RE: **Navarette Residence**
10516 Olympic NW
Grading Plan
Engineer's Stamp Date 7/20/17 (File: A12D028)

**RE: 10516 Olympic
Drainage file A12C028**

ENGINEER'S SEAL  7/20/17 DAVID SOULE P.E. #14522	NAVARETTE RESIDENCE 10516 OLYMPIC	DRAWN BY WCWJ DATE 7-20-17 21741-LAYOUT-5-29-17
	GRADING AND DRAINAGE PLAN	SHEET #
	 Rio Grande Engineering 1606 CENTRAL AVENUE SE SUITE 201 ALBUQUERQUE, NM 87106 (505) 872-0999	JOB # 21741

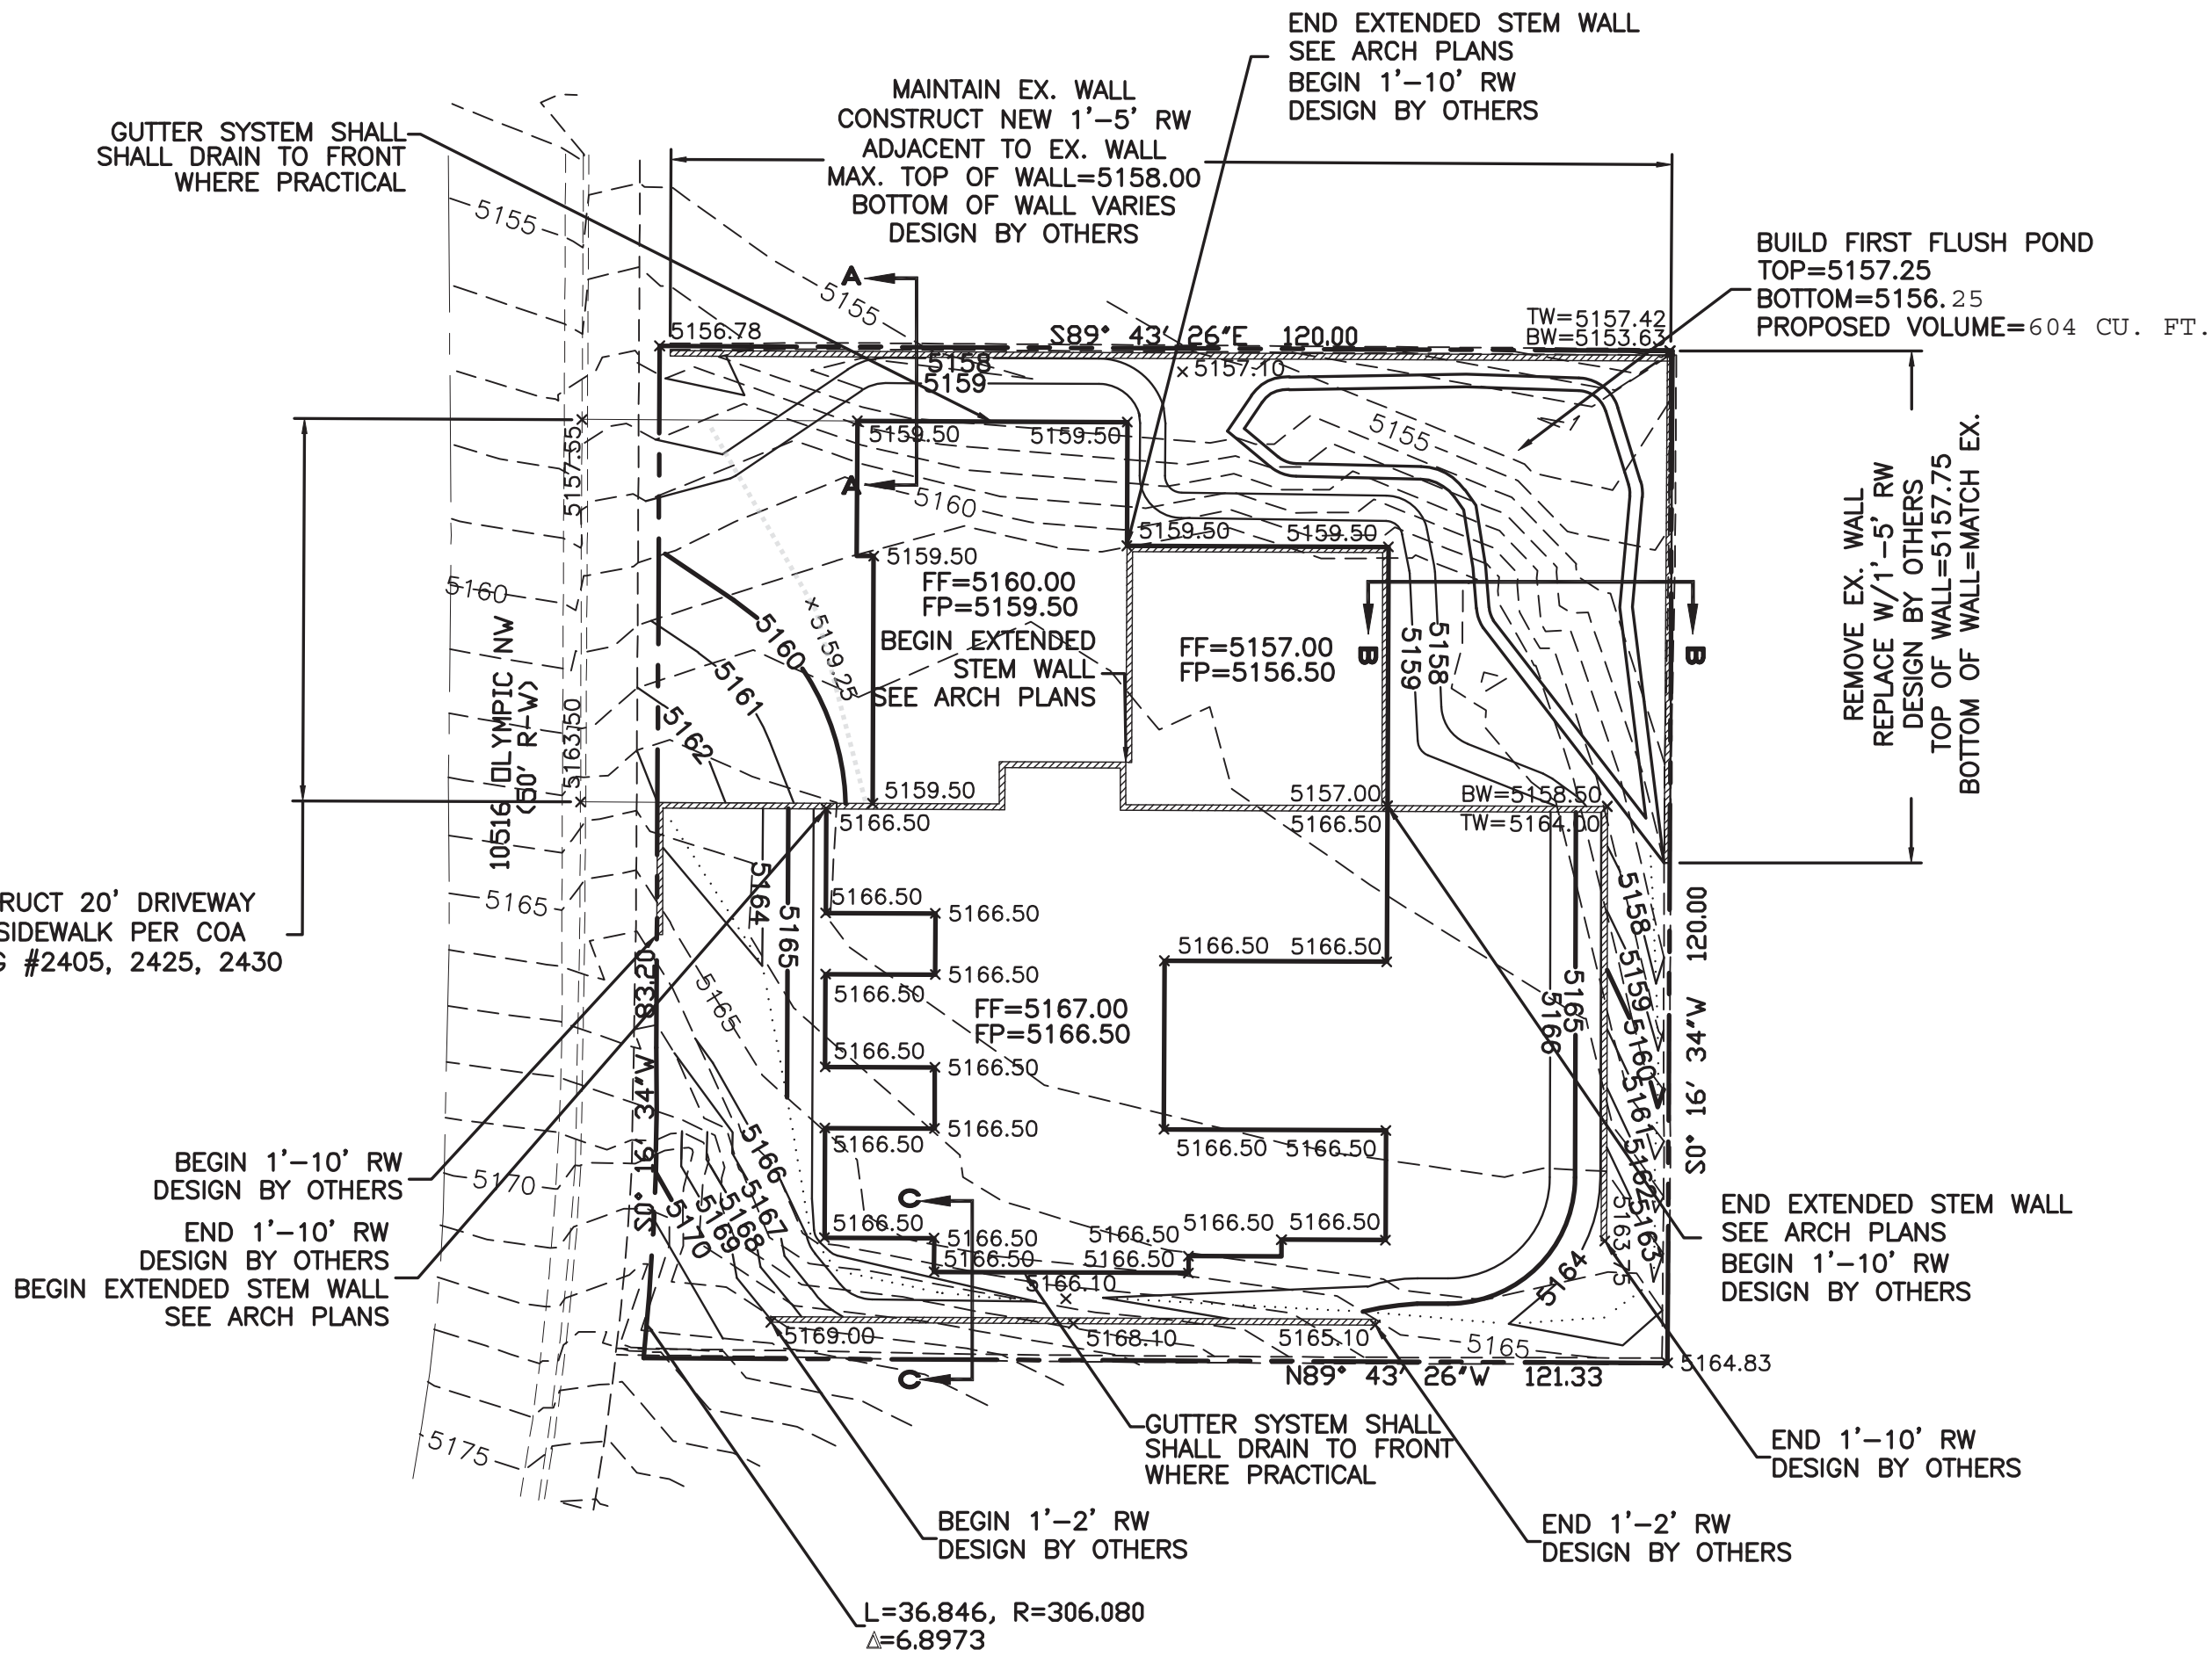
1. No adjustments (placing fill against or remove/replace) may be made to the existing wall without written owner permission. Instead a retaining wall will need to be set back from the property line and cannot constrain the adjacent homes' use (see section 22.5 on grading near the property line)

2. Historic flow pattern is through the NE corner of the lot, not to the ROW. For maintaining historic flow patterns to adjacent lots, the adjacent lots should see no increase...therefore any increase must be ponded and retained.

3. Guttering roof drainage to the front yard and to the ROW is an option to reduce flow to the NE corner. I looked at the front yard grades, this may be difficult to get into the ROW.

We have relocated the proposed wall so the existing wall is maintained.

We have modified the pond such that in increase in flow is retained and the historical patter remains.

We have added gutters as a note.
